# AGENDA PACKET Part 4 of 4

#### **MAY 17, 2022 MEETING**

|   | CAL#         | PAGE         |
|---|--------------|--------------|
| HARDART GARAGE, 12 GILBERT STREET, SOUTH SALEM  | Cal #11-22WP |              |
| RINI/LANGEL RESIDENCE,15 BENEDICT ROAD, SOUTH SALEM                                       | Cal #15-22WP | Cal #07-22SW |

|     | SLOCKING AT FLOATING EDG | SES AND SE       | CURELY FASTEN BOTH EDGES. EXISTING STORM WATER SYSTEM  | Λ.  |
|-----|--------------------------|------------------|--|---|
| 1 # | PERMITS<br>ISSUE         | 8-2-2021<br>DATE | PAUL DENNIS, A.I.A.  ARCHITECTS  26 GILBERT STREET, SOUTH SALEM, NY 10590 914-763-0959 pauldennis.architects@gmail.com | PLOT PLAN FLOOR PLANS, NOTES,   |

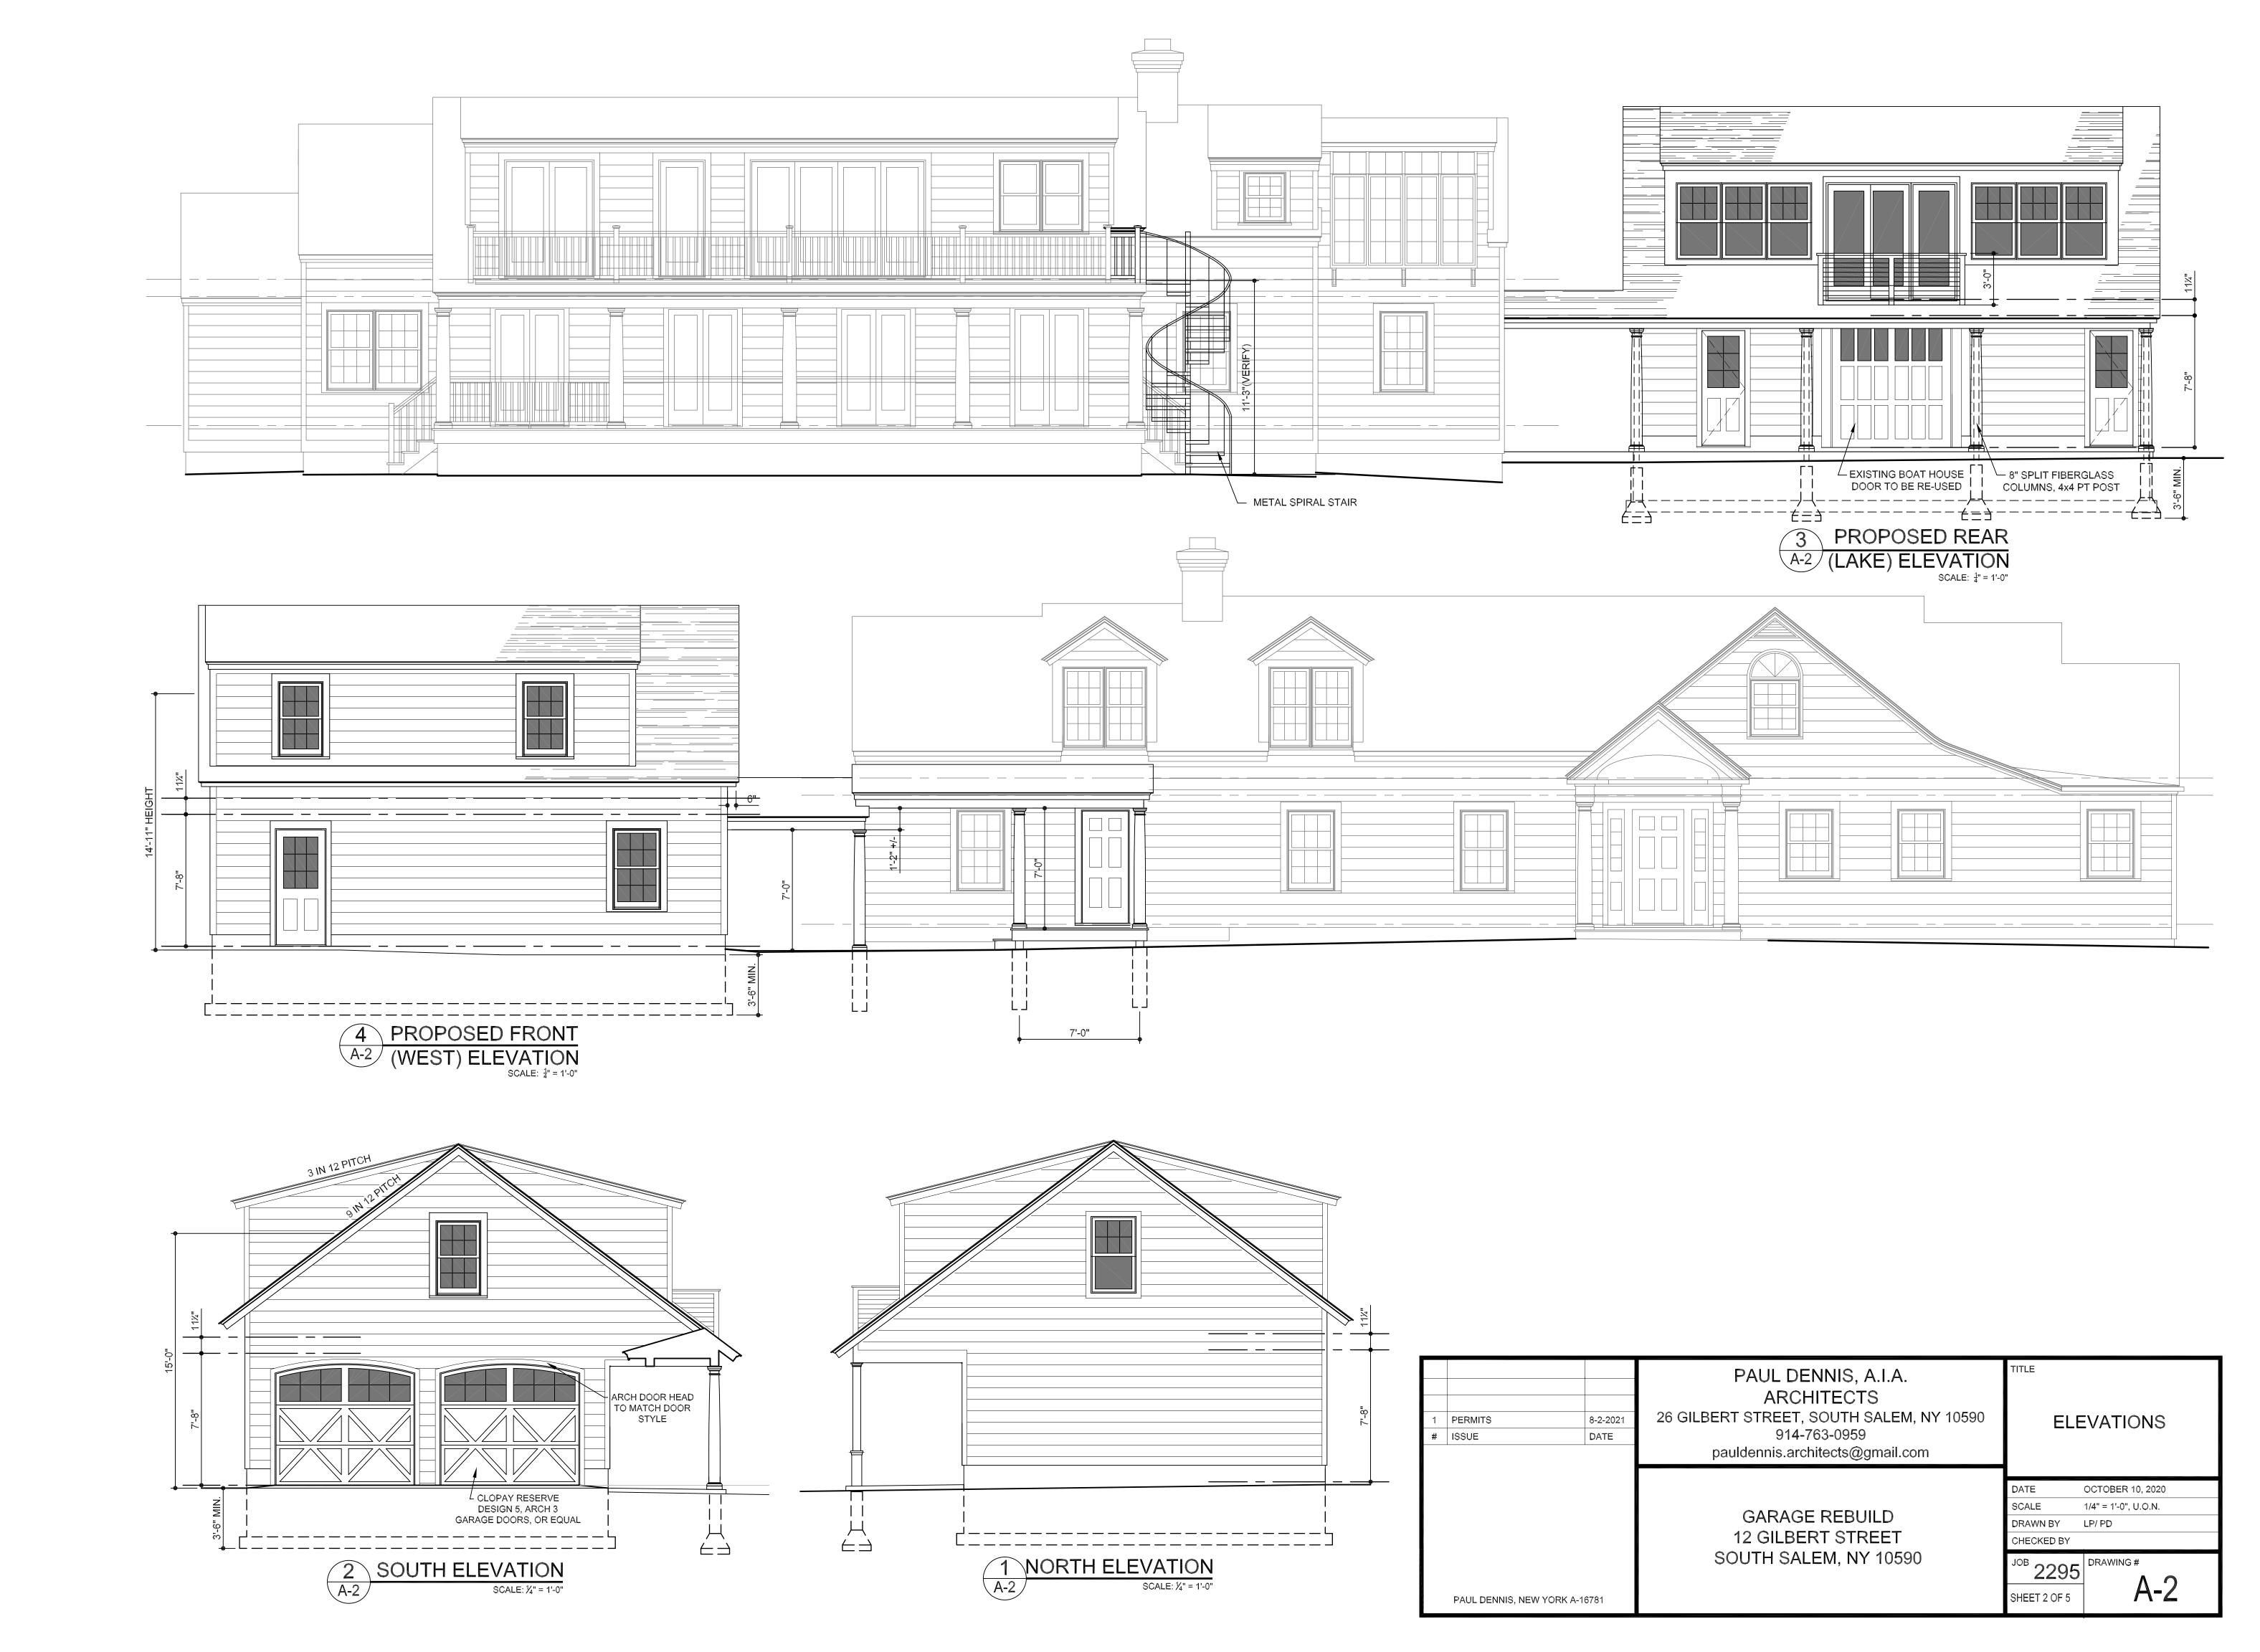
- 2. The applicant shall provide and existing conditions survey, signed and sealed by a licensed land surveyor. The survey shall become the basis for the site plan, which shall be provided as a separate sheet and at a scale of 1'' = 10'.

- 3. The plan shall illustrate and quantify the limits of disturbance (s.f.). The plan shall note that disturbance limits shall be staked in the field prior to construction. If the limits of disturbance exceed ≥5,000 s.f., the applicant will be required to conform with the New York State Department of Environmental Conservation (NYSDEC) SPDES General Permit (GP-0-20-001) and file a Notice of Intent (NOI) and MS4 Acceptance Form with the NYSDEC.

- 7. If no trees are proposed to be removed, a note to this effect shall be added to the plan.
- 8. Include erosion control measures on the plan, including, but not limited to, temporary construction access, silt fence, tree protection, construction sequence, etc. Details shall be provided and shall be in conformance with the most recent version of the New York State Standards and Specifications for Erosion and Sediment Control.

- 9. The location of the existing septic system and well shall be illustrated on the plan; the septic area shall be cordoned off during construction.
- 10. Depending on the extent of disturbance and new impervious cover, a wetland mitigation plan may be required.

Inspection of 12 Gilbert Street shows an existing garage on or near the location indicated in the submission. The CAC would like to know if this is a replacement on the same footprint which would have an impact on the wetland mitigation. Besides this clarification, the CAC would like to see a wetland mitigation plan including steps to insure the lake is protected during any removal and construction and a stormwater plan. The CAC would like the plans updated to indicate any trees that might be removed.

Drawing Title: Site Plan

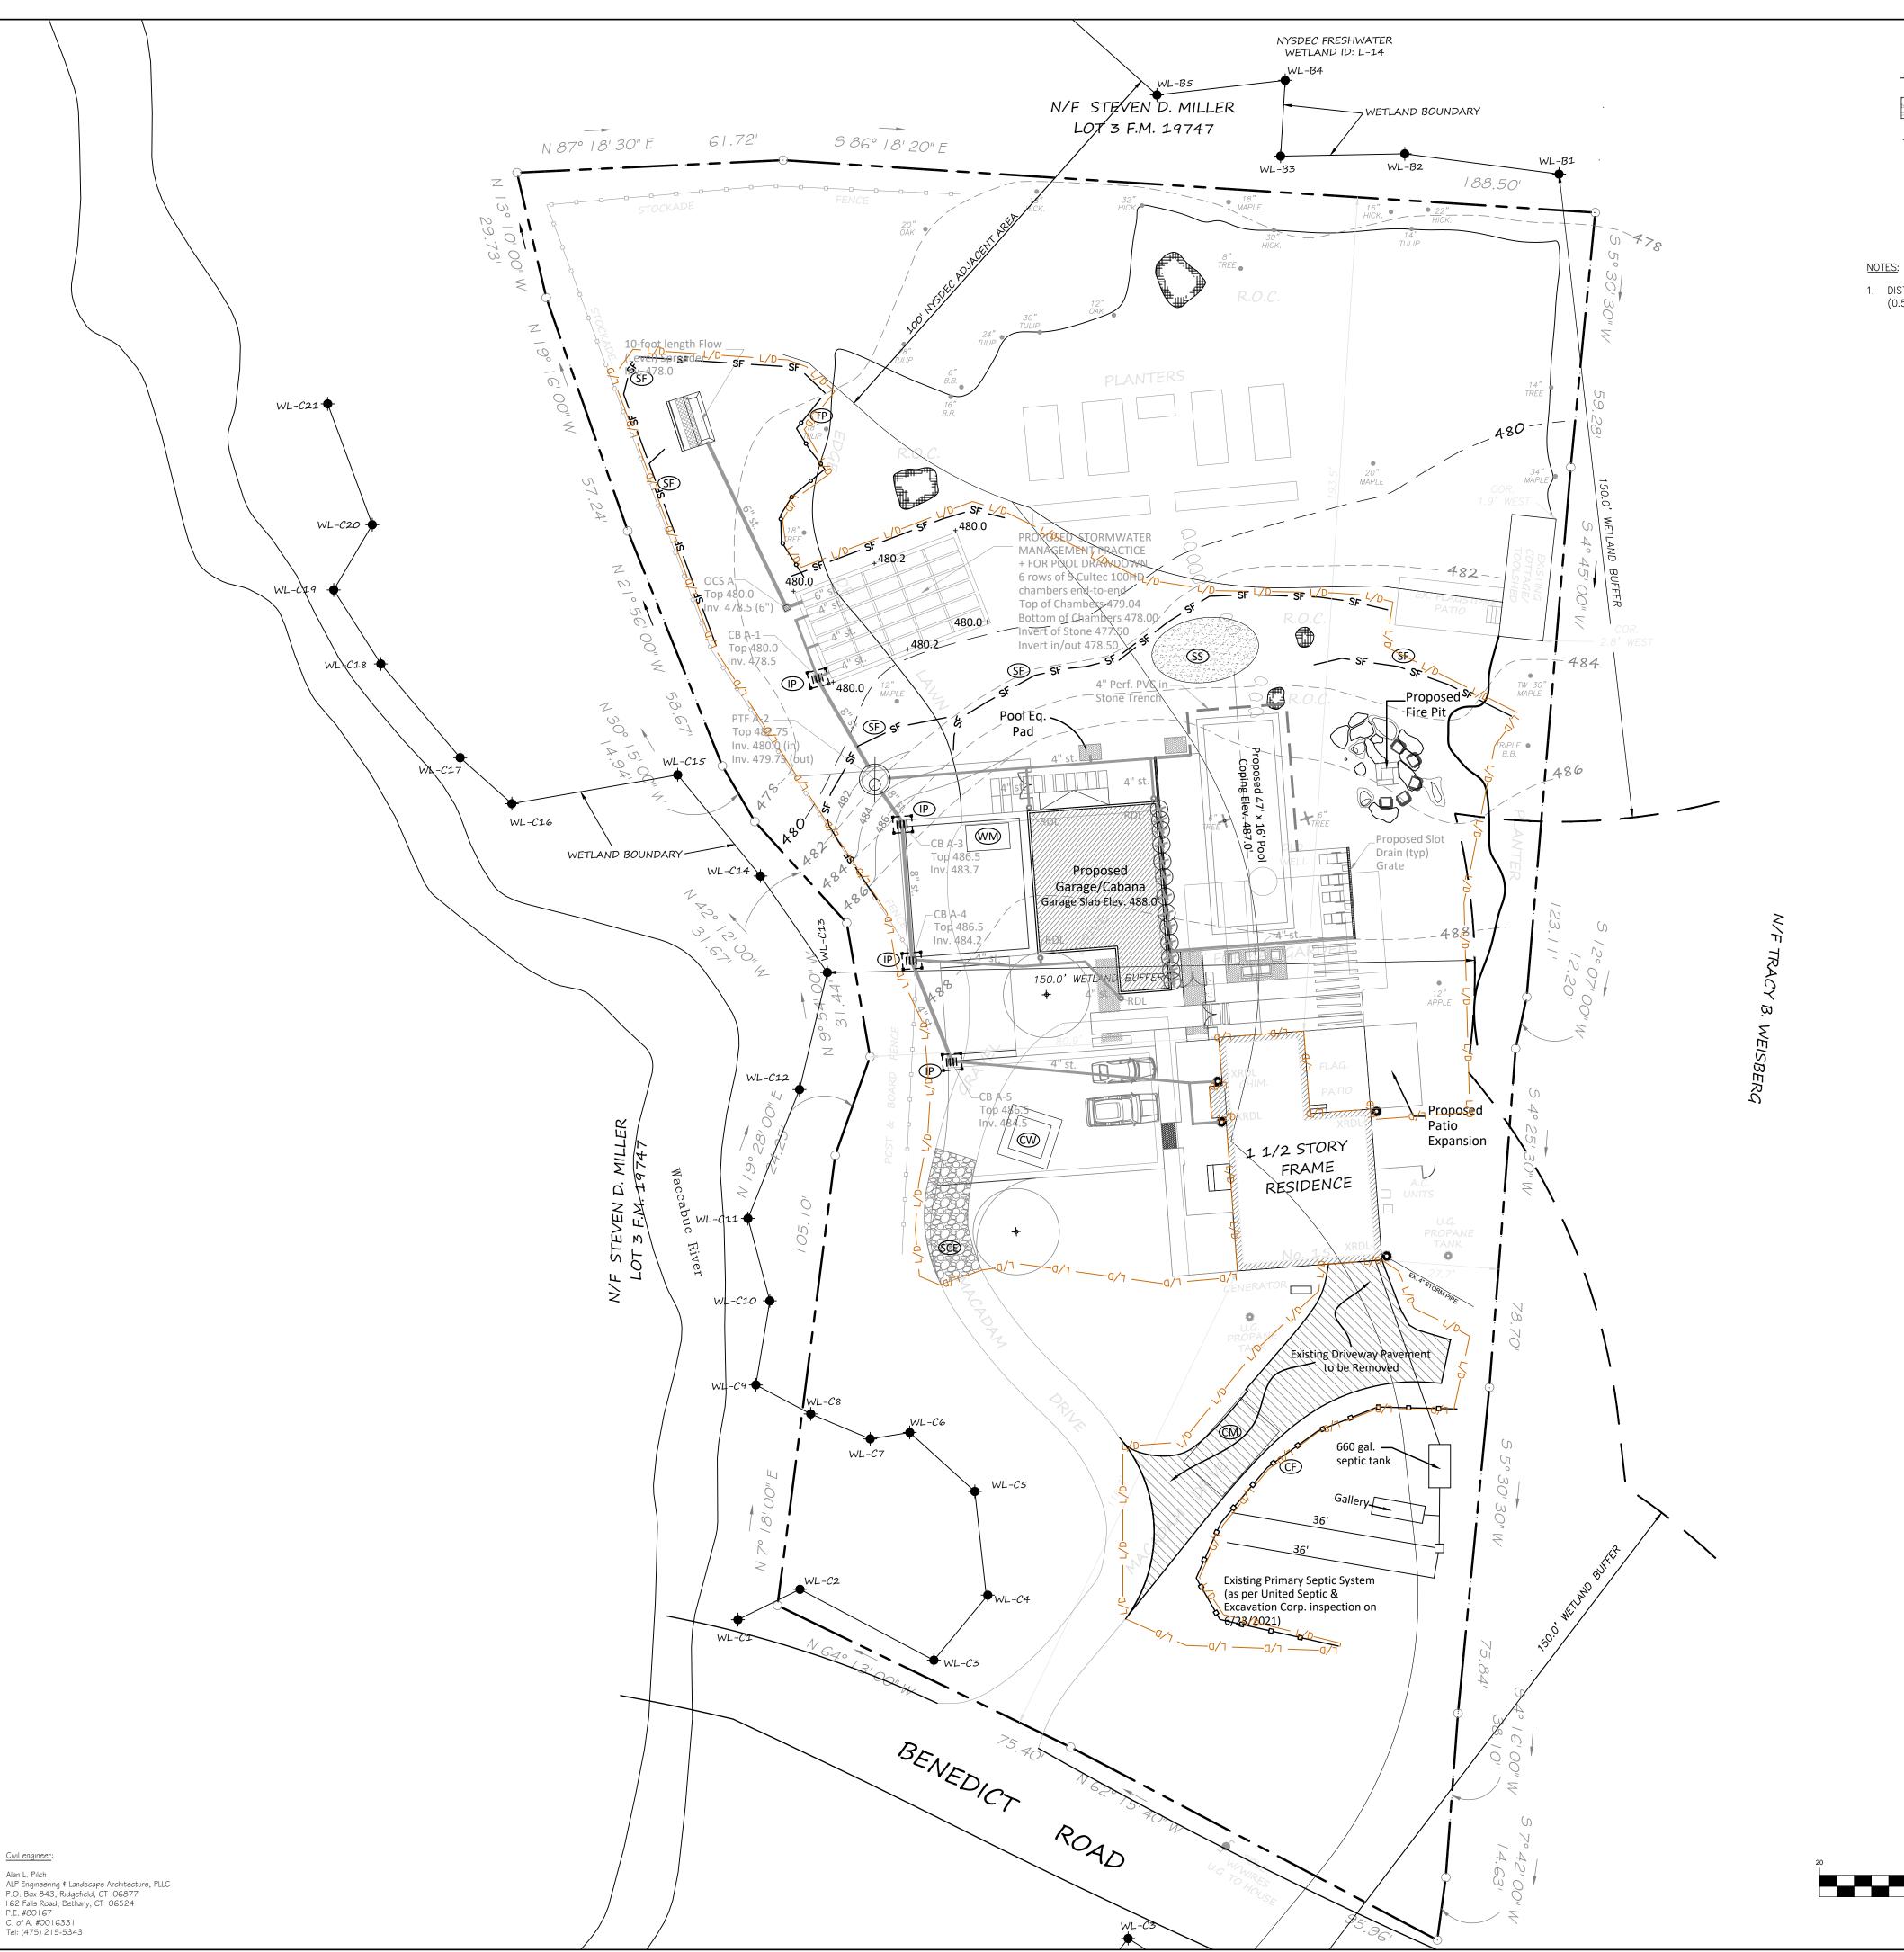
- 12. The plan shall provide details for the proposed outlet control structure (PTF A-2) and the proposed level spreader. The level spreader shall be aligned in parallel with the existing contours.

- 13. The Existing and Proposed drainage maps differ in the total area being used. Please clarify. The drainage maps also appear to capture neighboring property to the east. Please correct.

- 14. The plan shall note that disturbance limits shall be staked in the field prior to construction by a qualified professional.
- 15. The existing conditions plan sheet C-100 should depict all proposed removals.

- 16. The plan shall include how the area of removed driveway will be restored.
- 17. The plan shall demonstrate compliance with all applicable Westchester County Department of Health (WCDH) separation distance requirements between septic, wells, stormwater, pools, etc.

- 18. The names of the adjacent property owners and the location of any neighboring driveways, structures, buildings, wells and septic areas shall appear on the plan.

- 19. The plan shall illustrate the location of all existing and proposed utilities (electric, water, gas, etc.).

The applicant submitted a detailed wetland mitigation and stormwater management plan. Elements of the stormwater management system, such as the level spreader are deep in the buffer and near the Waccabuc River. The CAC would like to see those moved further from the wetland. For the wetland mitigation plan, the CAC would like to see a demarcation line between lawn and planting to ensure the plan is preserved. The type of water used in the pool should be identified for impact on draw down. The CAC would also like to understand how steep slopes on the property effect both wetland and storm water. A site visit would be useful.
